Oakland Housing
Authority

IFB #18-006

1619 Harrison Street Renovation and Modernization Project

Addendum #1

ELData -1.01 - 10 31 2018 form CID

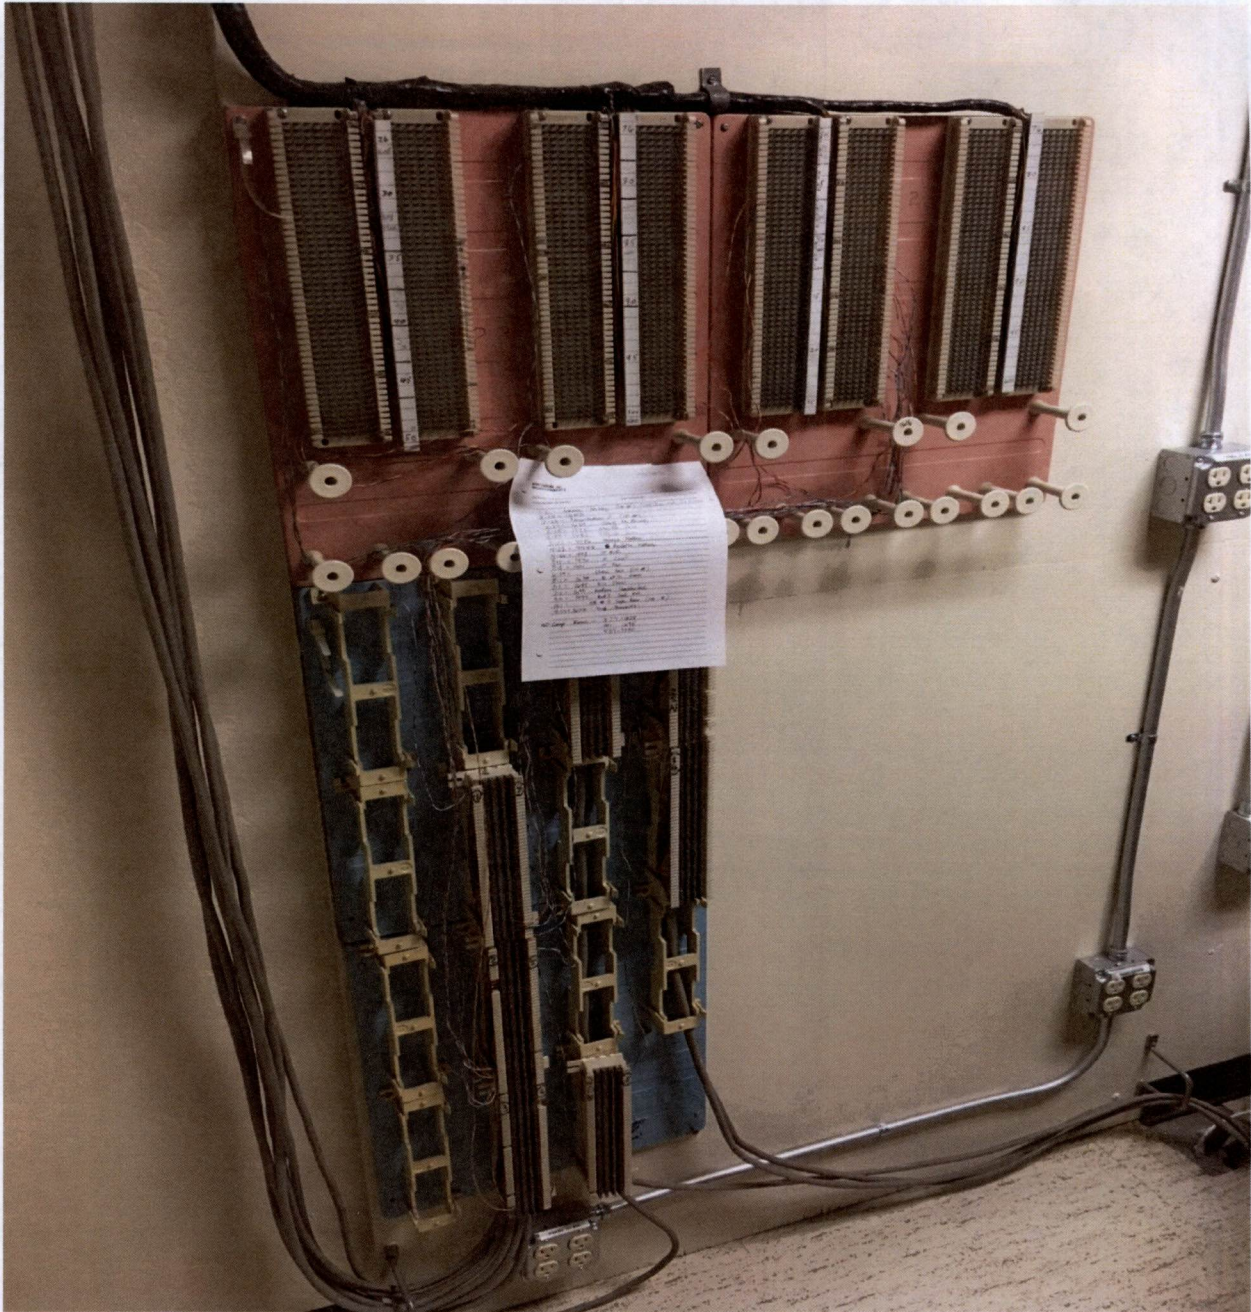
- 2) Demolition – Old telephone wiring in IT Lab Room to be demolished. Verify and coordinate with OHA prior. At no additional cost to OHA. See attached sheet ELData1.01

Unused – Verify in field - To be Demolished in Room 229 IT Lab
